The Commission has issued the enclosed Amendment No. 57 to Provisional Operating License No. DPR-21 and Amendment No. 47 to Facility Operating License No. DPR-65 for the Millstone Nuclear Power Station, Unit Nos. 1 and 2. The amendments consist of changes to the common Appendix B Environmental Technical Specifications (ETS) in response to your application dated March 21, 1978. Your August 15, 1978 submittal supplements your application dated March 21, 1978 for Appendix A organizational changes.

Amendment No. 57 License No. DPR-21

Amendment No. 47 License No. DPR-65

NOTICE OF ISSUANCE OF AMENDMENTS TO OPERATING LICENSES

FIGURE 5.1-1 Chart of Organizational Responsibilities for Northeast Utilities and the Northeast Nuclear Energy Company.

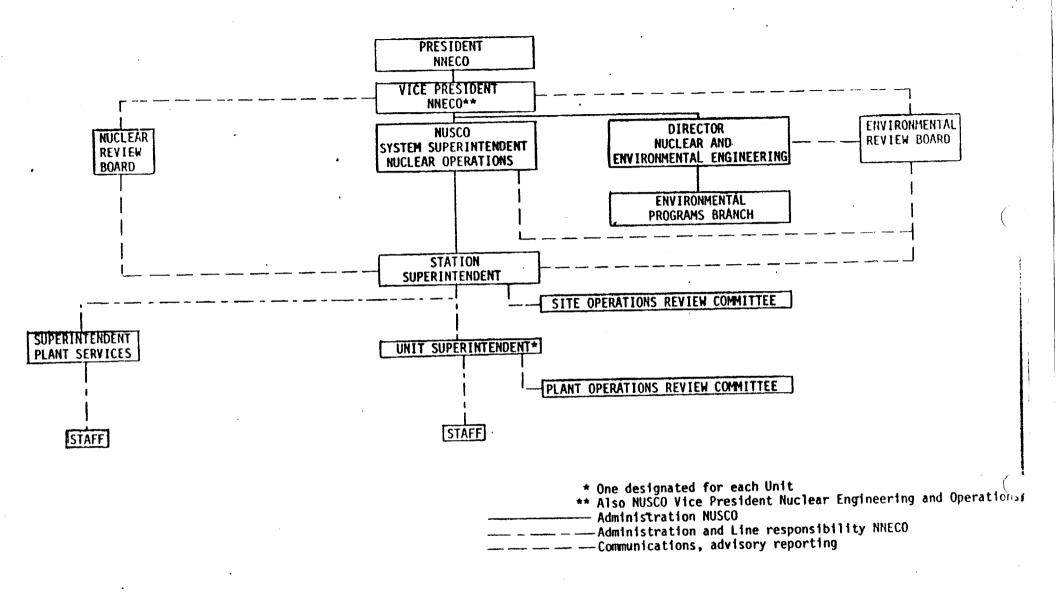
The amendments also revise Sections 5.1.5 and 5.1.6 and Figure 5.1-1 to reflect management title changes necessitated by a reorganization of the management of the Nuclear Engineering and Operations Departments. These changes are consistent with the Appendix A Technical Specifications in which the same organizational changes were approved and incorporated into the licenses in previous license amendments. The instant amendments would merely reflect in Appendix B. Technical Specifications, changes previously made in the Appendix A Technical Specifications. The organizational structure, although unique for the Millstone facilities continues to be equivalent to the organizational structure that we have approved for other nuclear power plants. On this basis, we find these changes to be acceptable.
